Planning Services

Gateway Determination Report

LGA	North Sydney
PPA	North Sydney Council
NAME	Proposal to amend height of building control and introduce a minimum non-residential floor space ratio for land at 41 McLaren Street, North Sydney (224 homes, 0 jobs)
NUMBER	PP_2018_NORTH_001_00
LEP TO BE AMENDED	North Sydney Local Environmental Plan 2013
ADDRESS	41 McLaren Street, North Sydney
DESCRIPTION	Lot 1 in DP 557103
RECEIVED	4 May 2018
FILE NO.	IRF18/2893
POLITICAL DONATIONS	There are no donations or gifts to disclose and a political donation disclosure is not required.
LOBBYIST CODE OF CONDUCT	There have been no meetings or communications with registered lobbyists with respect to this proposal.

Figure 12: View looking south-west from Falcon Street overpass (Architectus, 2017), including Architectus's recommended consolidated tower development at 20 Ward, 56 Berry and 66 Berry Streets (site B).

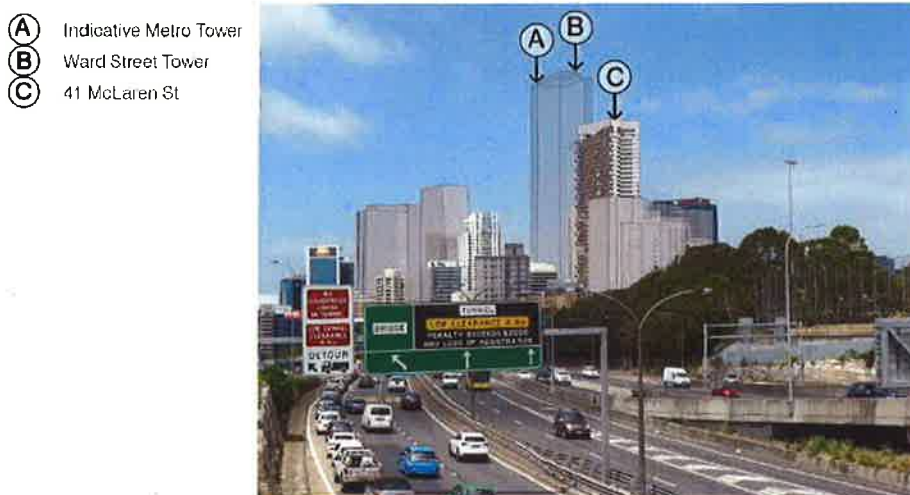
As illustrated in **Figure 12**, the proposed development will be visually apparent as part of the North Sydney cityscape. The proposed tower is perceived to be dominant due to its location on the northern extent of North Sydney's CBD. It is considered that the proposed height and scale of the proposed development is appropriate given the changing strategic nature of North Sydney, and the anticipated future development growth for this part of the North Sydney CBD. This scale will also help denote the importance of this part of the CBD as including the new metro station. It is considered that the visual impact will need to be further assessed at the development application stage if the proposal is to proceed.
